10/13/95	ADDENDUM 1
DATE	REVISION
STATE OF HAWAII DEPARTMENT OF TRANSPORTATION HIGHWAYS DIVISION ROOF WALKWAYS COMMON WORK H-3 FINISH (UNIT III) FAIP NO. I-H3-1(75), UNIT III T.K. TUNNEL/ACCESS ROADS SCALE: 1" = 20' DATE: JUN 1995	
SHEET NO. 7A1	OF 5 SHEETS

STATE OF HAWAII
DEPARTMENT OF TRANSPORTATION
HIGHWAYS DIVISION
**ACCESS OPENING SAFETY
RAILING — HALAWA**
COMMON WORK
H-3 FINISH (UNIT III)
FAIP NO. I-H3-I(75), UNIT III
T.K. TUNNEL/ACCESS ROADS
SCALE: NONE
DATE: JUN 1995
SHEET NO. 7SI OF 6 SHEETS

POTABLE WATER TANK

TUNNEL FLUE WEEP DETAIL

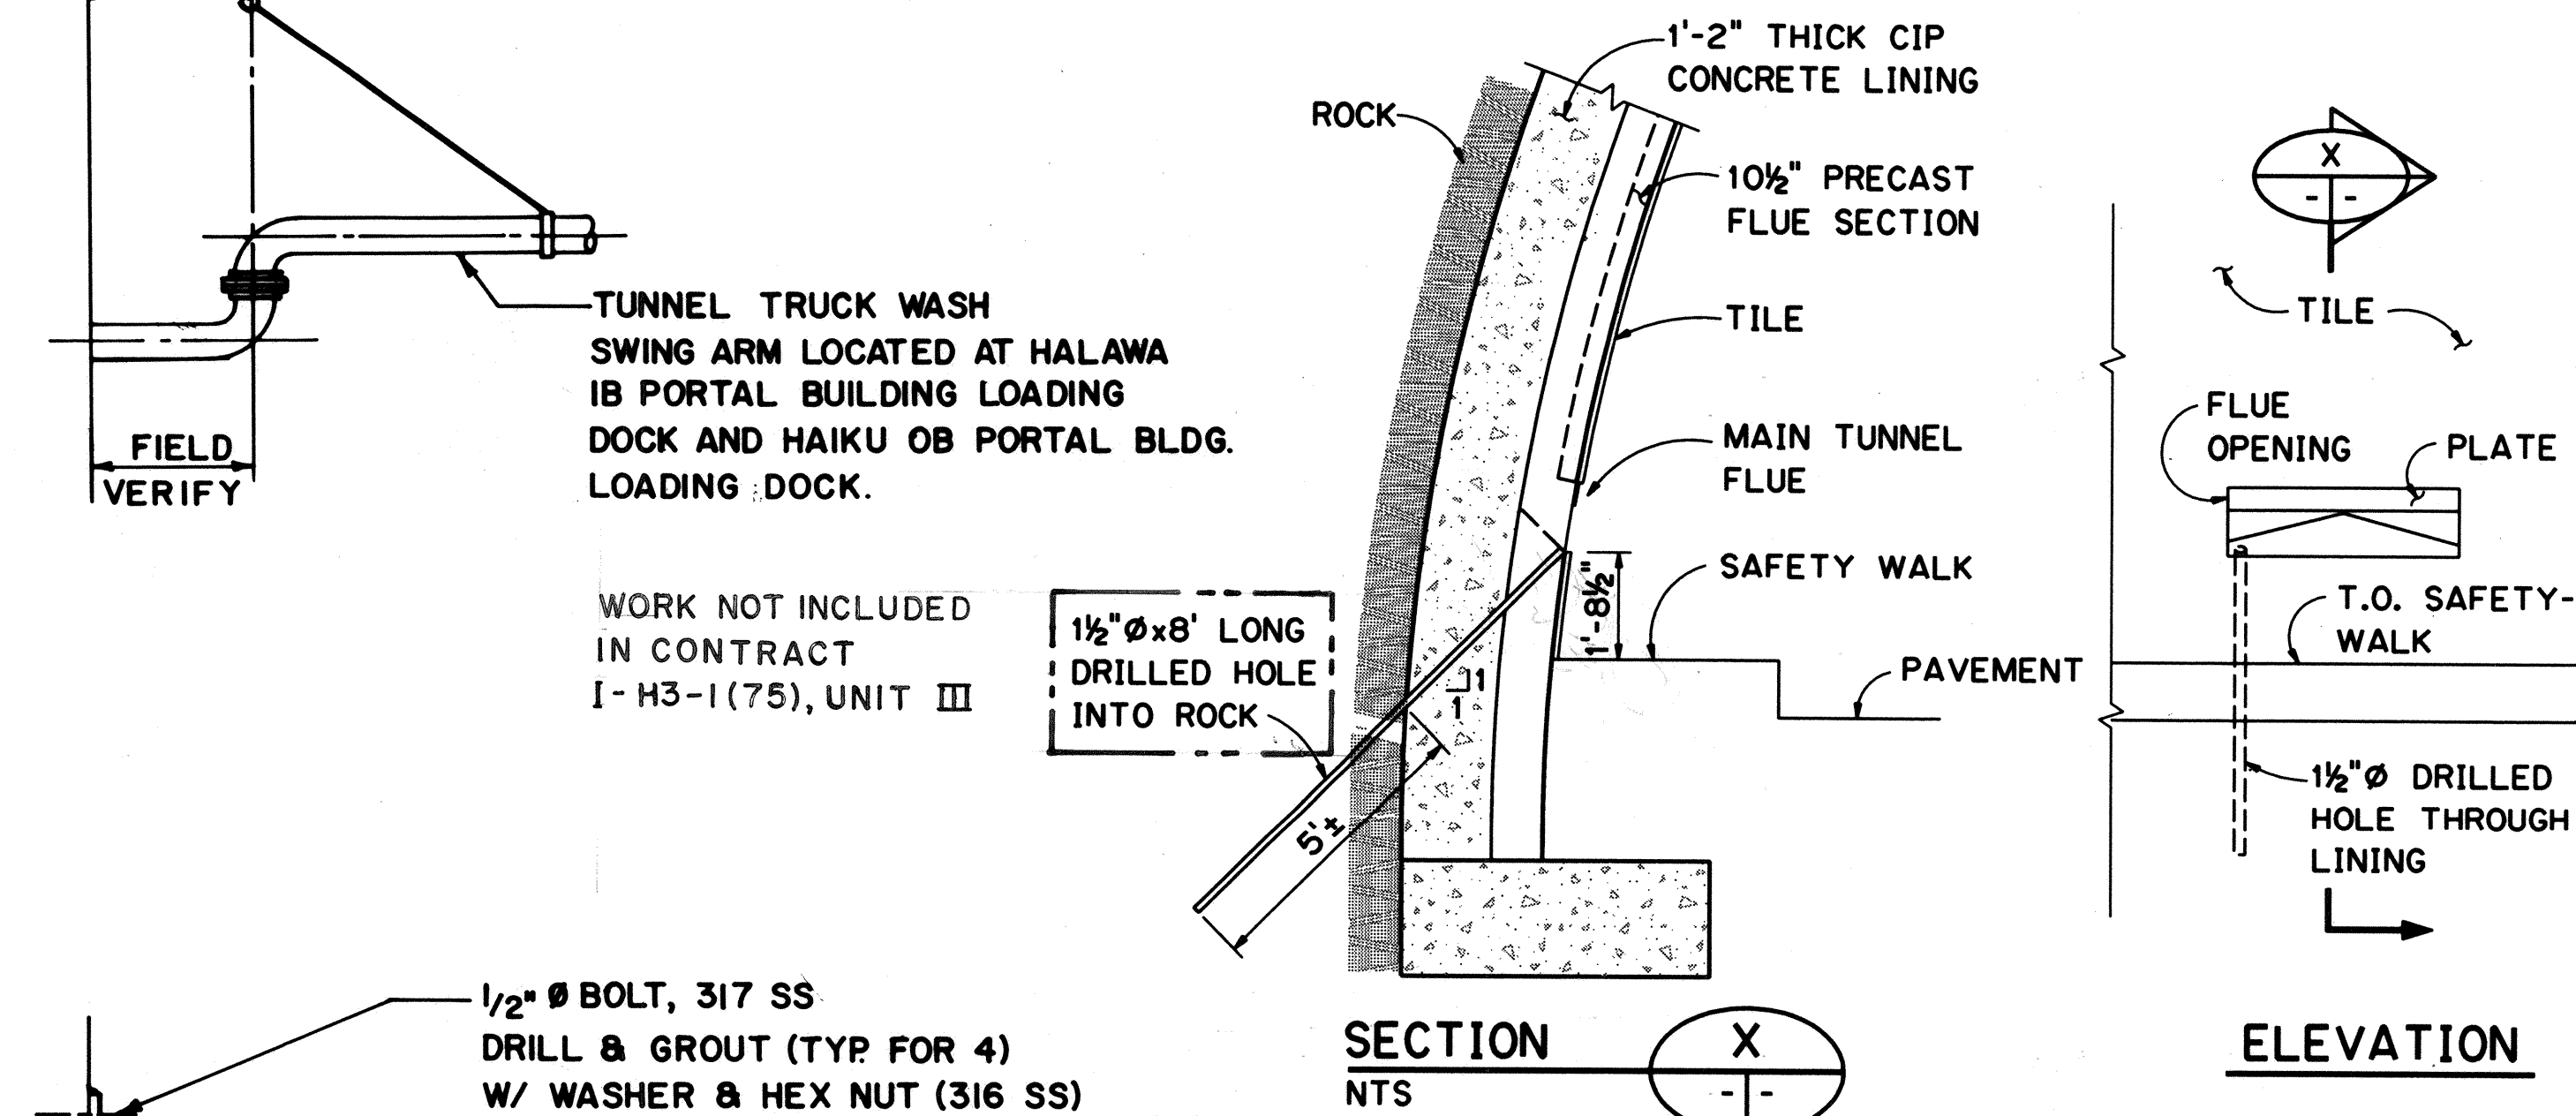
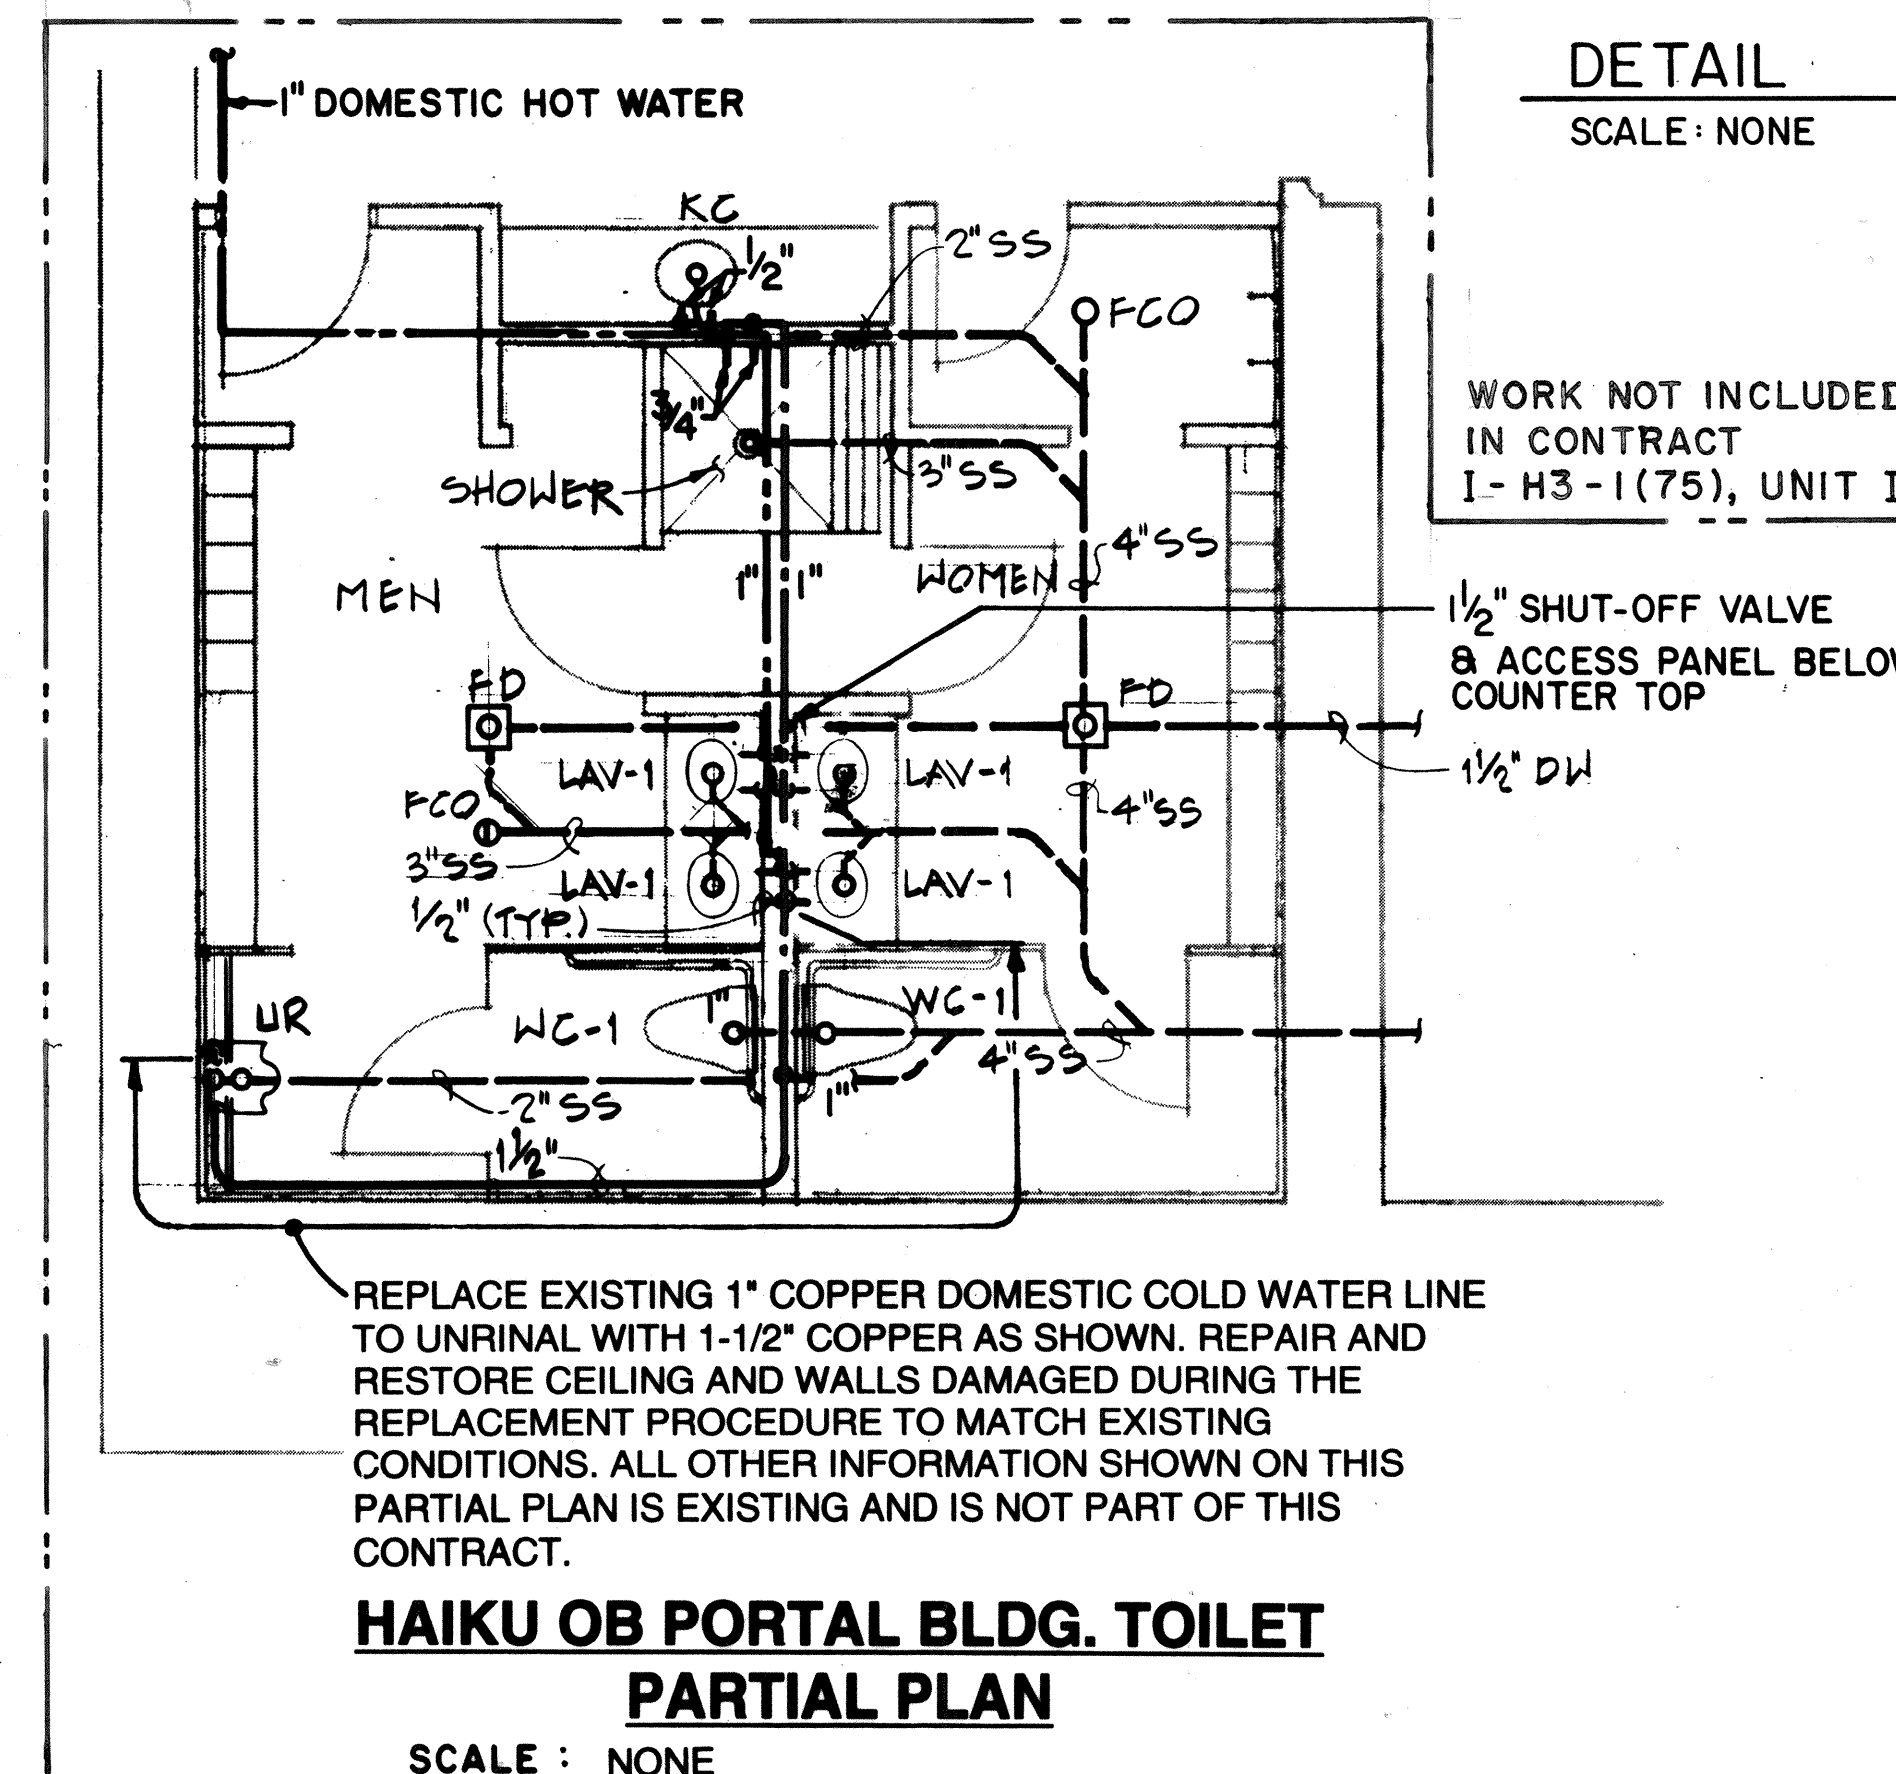
DATE	REVISION
10/27/95	ADDENDUM 2 - ADDED TUNNEL FLUE WEEP AND O&M SHOP FLOOR DRAIN DETAILS
10/13/95	ADDENDUM 1
